*Proposed Bowdens Mine SSD 5765
Surface Water Submission Report to the
Independent Planning Commission*

On behalf of the Lue Action Group

By Shireen Baguley

Figure 4 Mine Site Area calculation

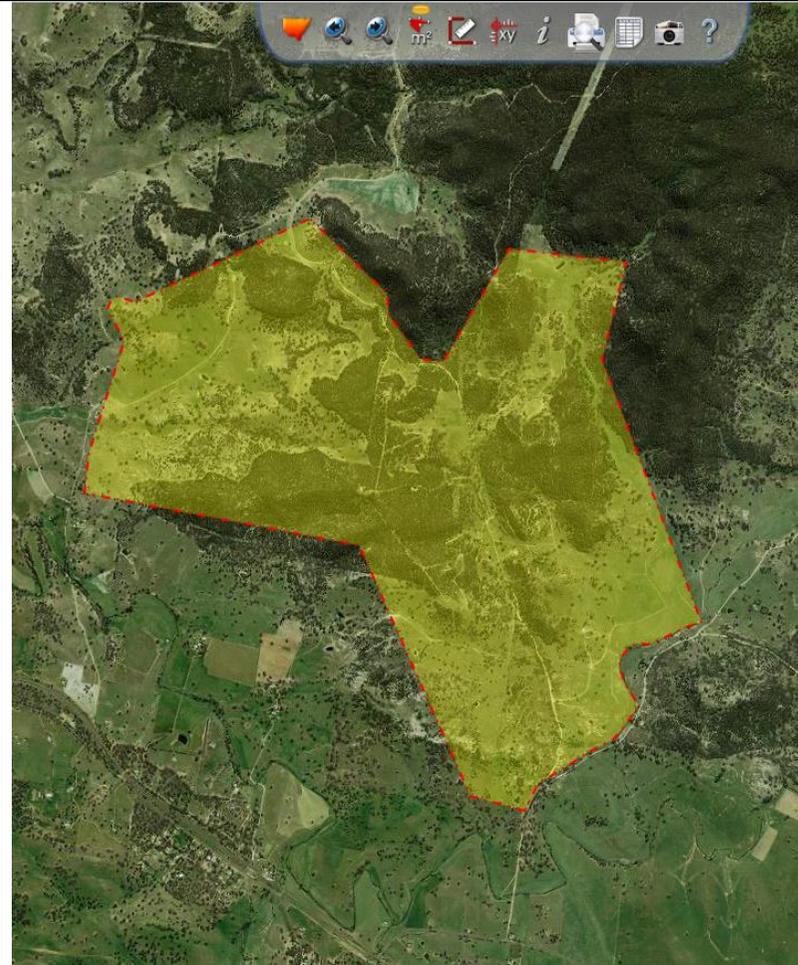
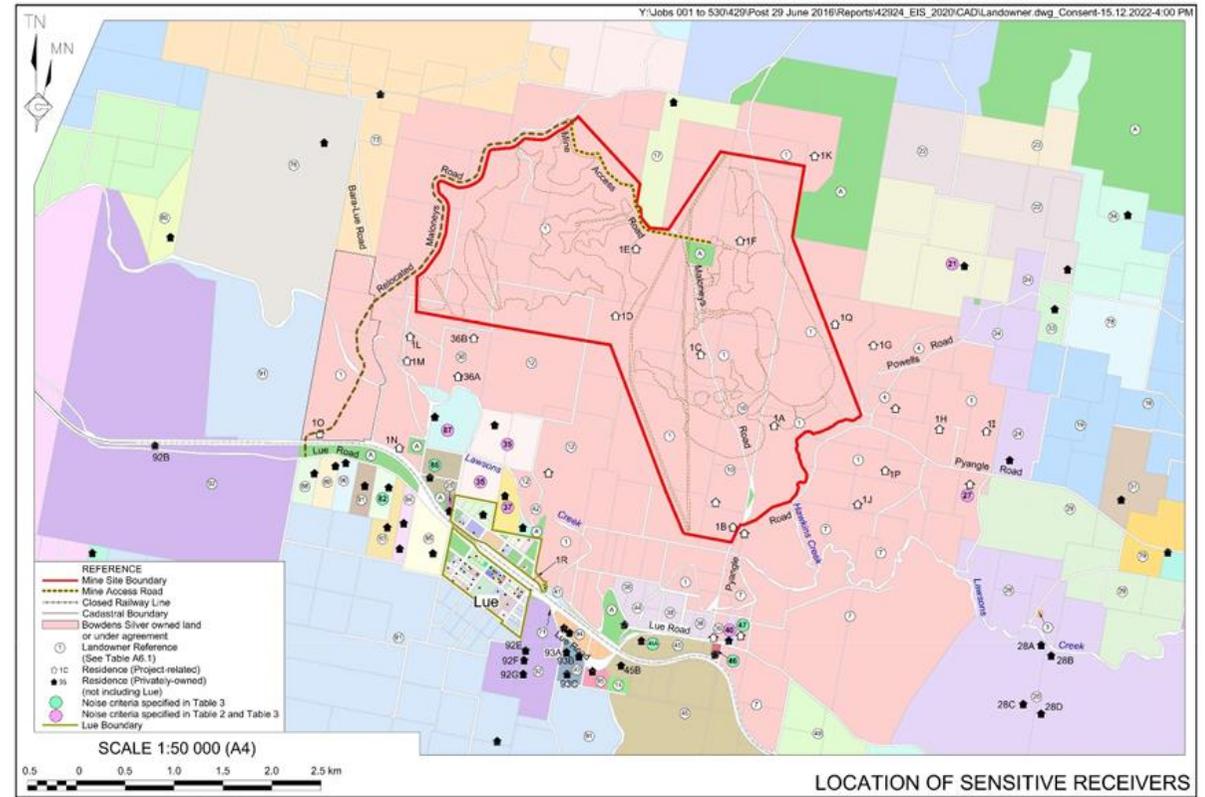
- f. A calculation of the proposed Mine Site boundary using SIX Maps shows this area is actually approximately 1007 Ha, or nearly twice that reported by Corkery (2022) (Figure 4).

- g. It is unclear what the true area of the Mine Site catchment is. This lack of clarity casts uncertainty over the modelled surface water impacts.

Figure 5 Streamflow recorded in Hawkins Creek at Bingmans Crossing

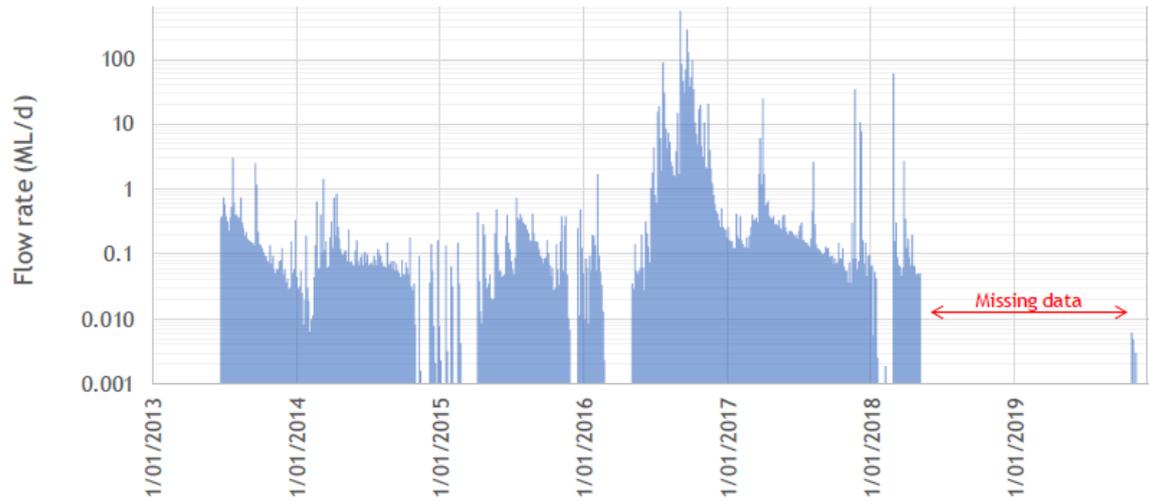
- b. The model has excluded any dry periods (i.e. see Figure 5) in what calibration was undertaken and not undertaken any verification using the local stream gauges.

- ii. WRM (2022, p 6 – 43) presents flow data for Hawkins Creek at Powells Road (Station No. 421195) and Bingmans Crossing (Station No. 421194) (**Figure 5**).

- iii. WRM **did not verify the water balance model**. There is data available for use, with the flow data gathered at Powells Road and Bingmans Crossing. This could have been used to verify the parameters adopted. This is best practice in modelling. It is unclear why this was not done.

Figure 7 Location of Monivae and v-notch weir

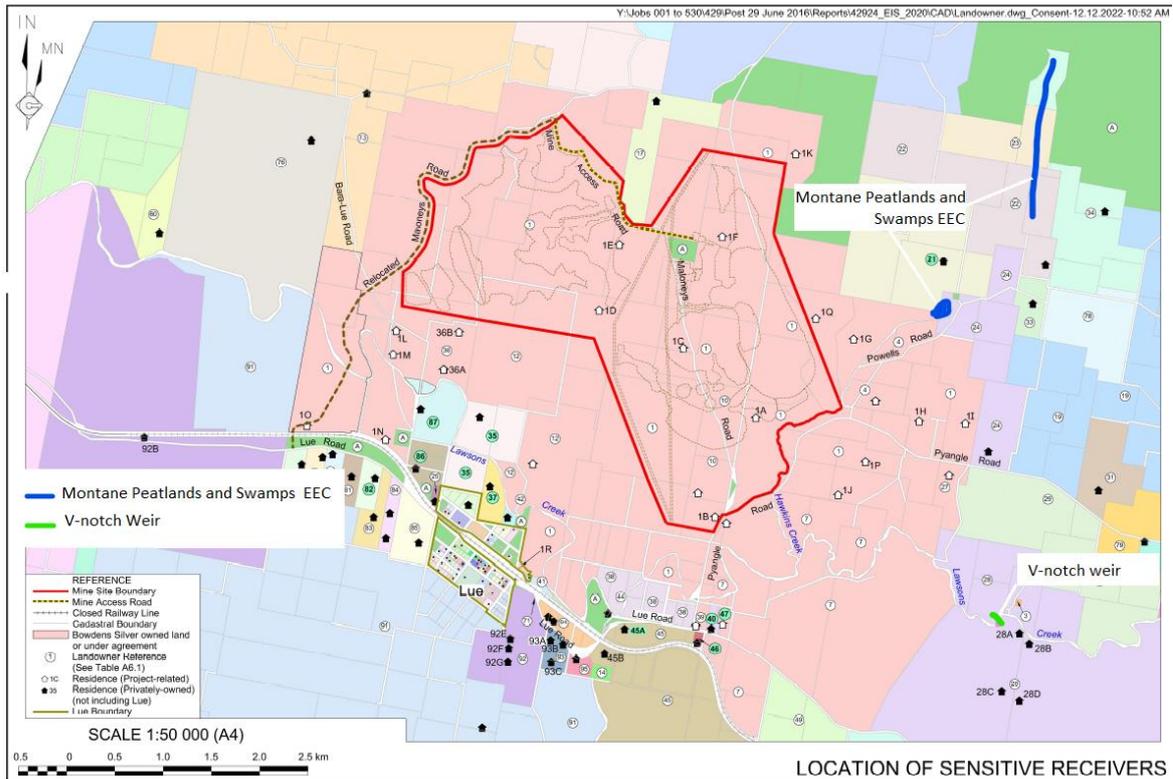
- dd. The landholder of Monivae was approached to ascertain if flows in Lawson Creek could be measured at this location, as this property sits just upstream and outside of the proposed mine site, being property #28 in Figure 7, shown shaded in purple and straddling Lawson Creek.

- gg. A temporary v-notch weir was constructed at a suitable location on Lawson Creek. The location had a hard rock crossing to form the base and alluvial clay banks. This formation minimises any seepage losses. The location of the weir is shown in Figure 7 and Figure 8. The construction of the weir is shown in Figure 9. The measurement of the weir is shown in Figure 10. This was taken on 21st February, 2023. This followed a storm event the preceding day, which recorded 9mm at Monivae. The flow rate at this location for the 'Monivae catchment' is 3.1L/s, or 0.27ML/d.

Figure 8 Lawson Creek catchment

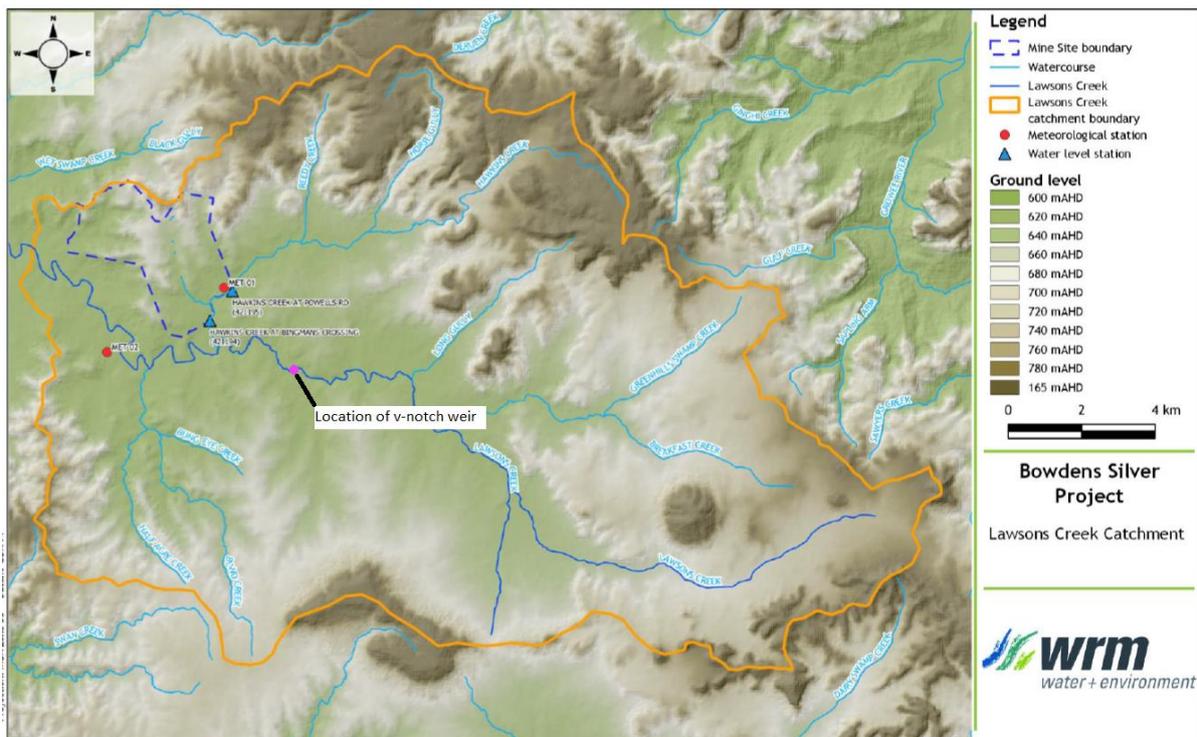
- ee. Lawson Creek flows through this property, and it lies just upstream of the Hawkins Creek confluence.
- ff. The LawsonCreek catchment is shown in Figure 8. WRM (2022) advises the following catchment areas:

Using Figure 3.5 from WRM (2022), it is estimated that the southern catchment contributing to Lawson Creek between the Monivae property and Walkers Creek is 45 km² and between the Hawkins Creek confluence and Walkers Creek is 29 km²

Figure 14 Location of BG Centre North dam and sediment dams (shown in pink), where the waterways are on major (3rd order or higher) streams (Source DPE 2022, WRM 2022)

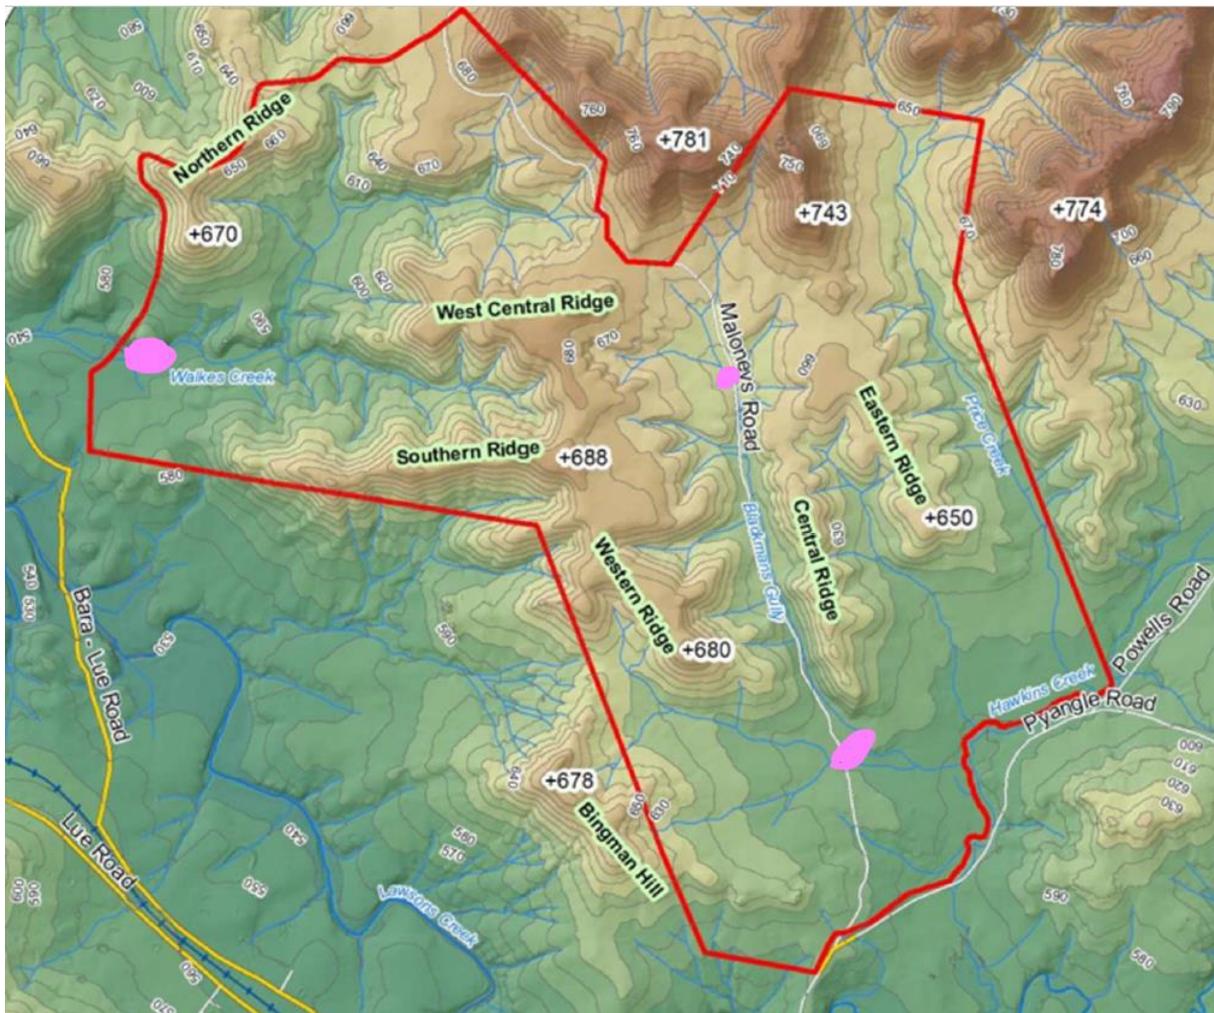
- k. It is also noted that the two exemptions stated above rely on any dams being located on ‘minor waterways’.
- l. As per the above WRM (2022) state “No sediment dams would be constructed on a major stream”. It would appear that the author of this statement did not do a cursory check of the topography of the region or did not understand the definition of a ‘major’ versus a ‘minor’ stream. As defined by the Regulation , a minor stream means (ii) *that is identified as a first or second order stream, or part of such a stream, as determined in accordance with the system set out in Schedule 2.* Major streams are third order or higher. Two of the proposed sediment dams are in fact located on ‘major streams’ (Figure 14).

- s. Harvestable rights dams cannot be located on or within 40 metres of a third-order or higher order stream¹ (WaterNSW, 2022). Using the mine site topography presented by DPE (2022), at least one harvestable rights dam (BG Centre North – refer Figure 14) is located on a ‘third-order or higher’ stream.

Figure 17 Location of some of the Montane peatlands and swamps EEC in proximity to the Bowdens proposed mine site (Source DPE 2022)

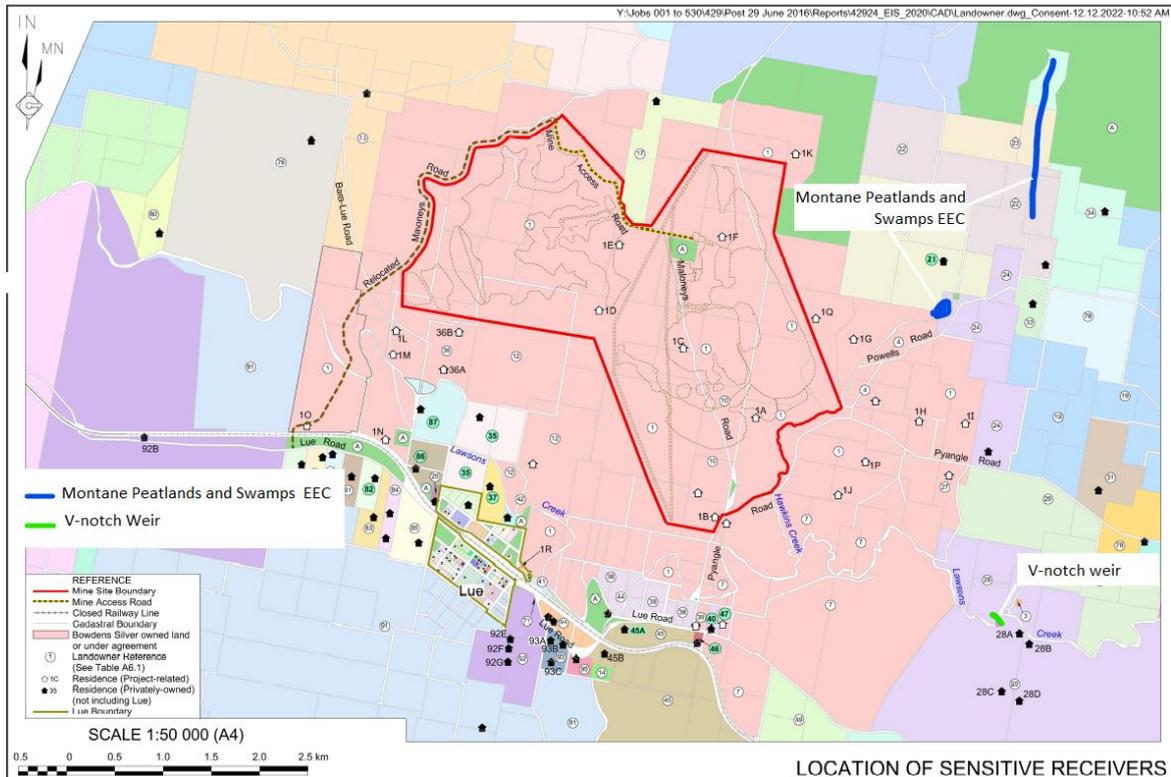
- r. It is known that additional Montane Peatlands and Swamps EEC exist closer to the Bowdens' site. The location of one of these is shown in Figure 17. Additional Montane

- v. All Montane Peatlands and Swamps in and adjacent to the Bowdens' proposed mine site must be identified, baseline data gathered, potential impacts assessed and appropriate protection put in place. Given Bowdens' dismissive response to this issue being raised previously, and the inability of its own consultants to correctly identify this EEC, it is recommended this be done by an independent consultant with appropriate expertise.

Mine Site area unclear

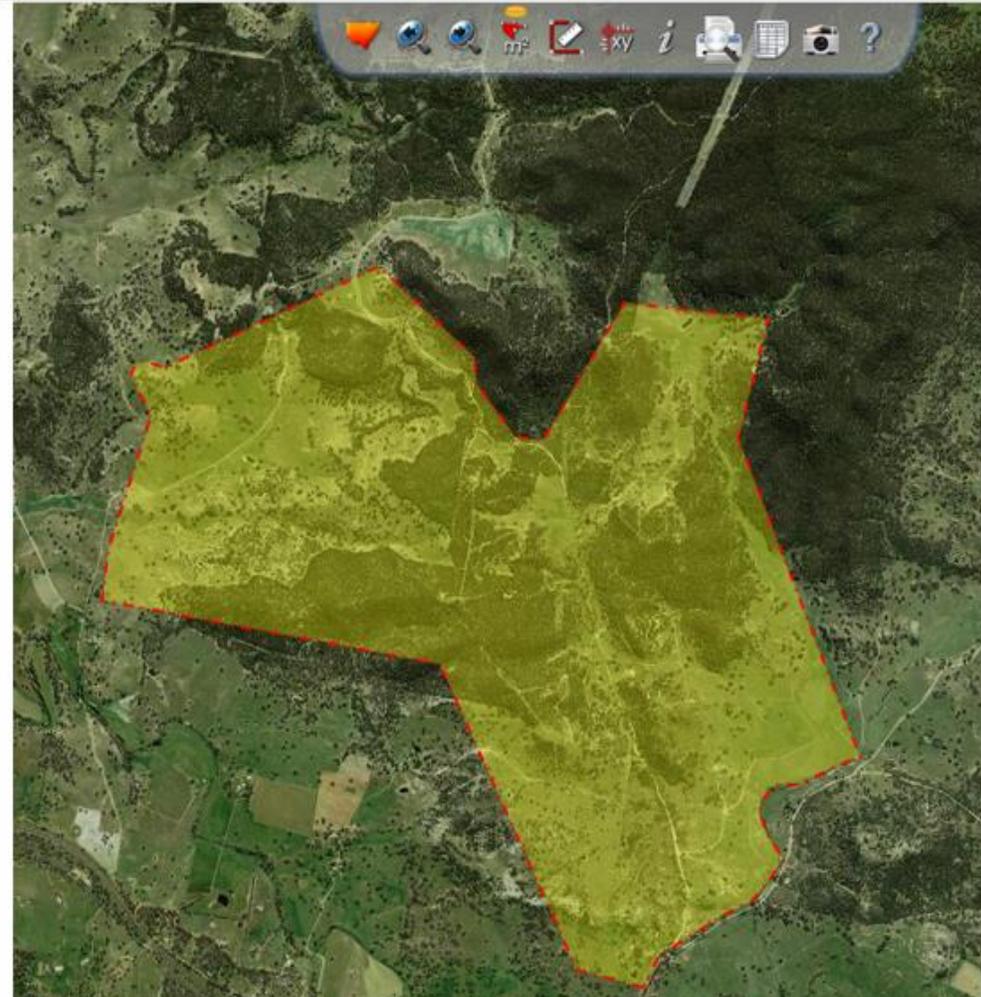
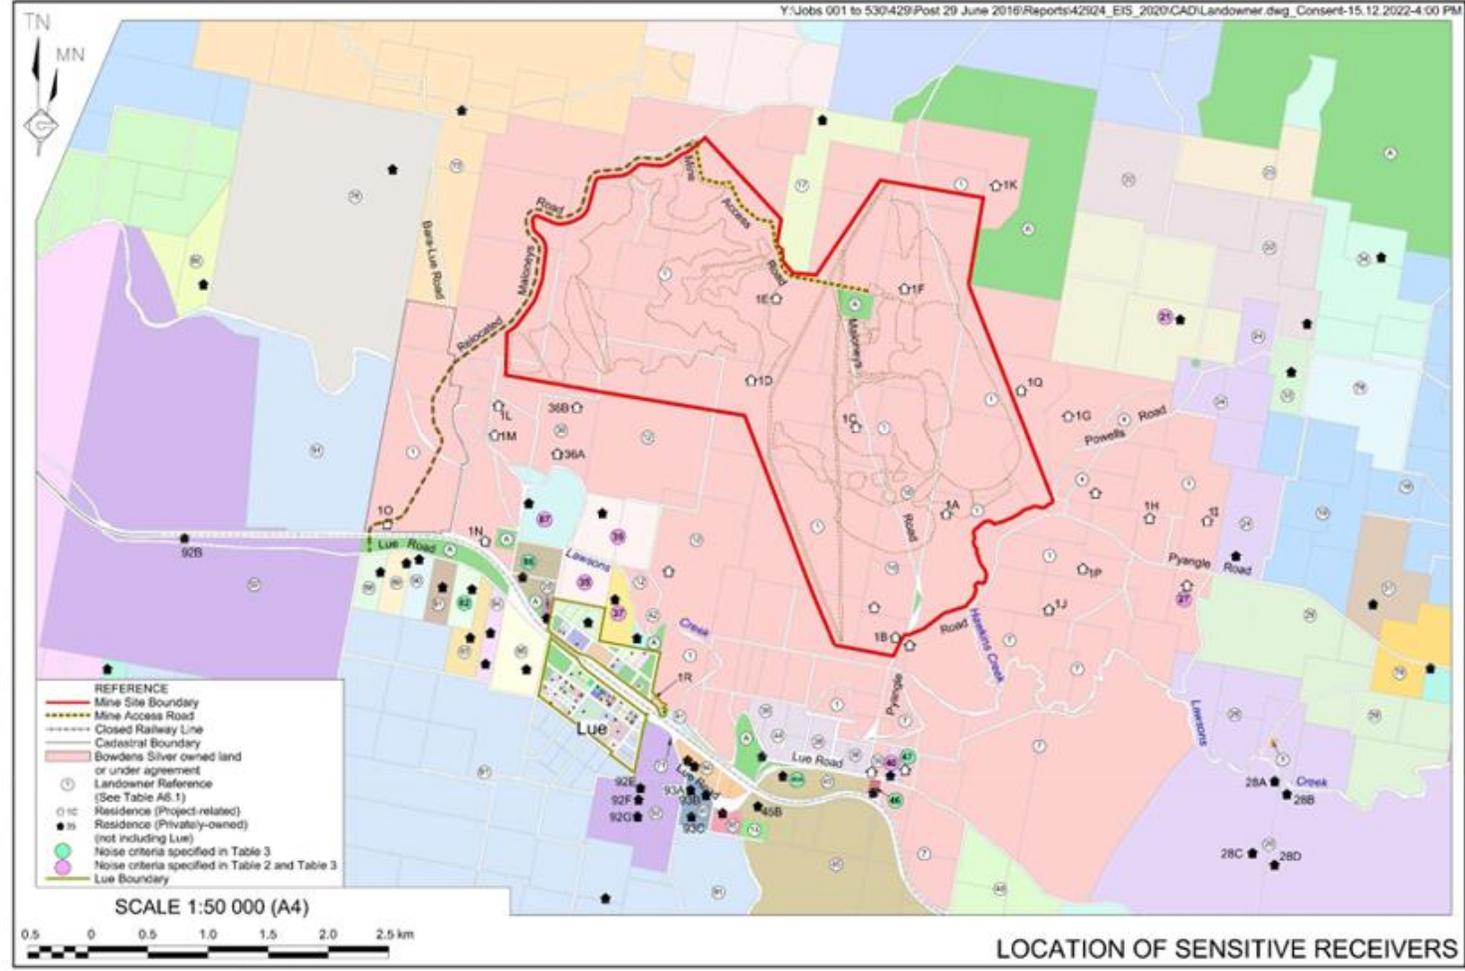
Proposed mining operations cover the majority of the Mine Site boundary (shown in red)
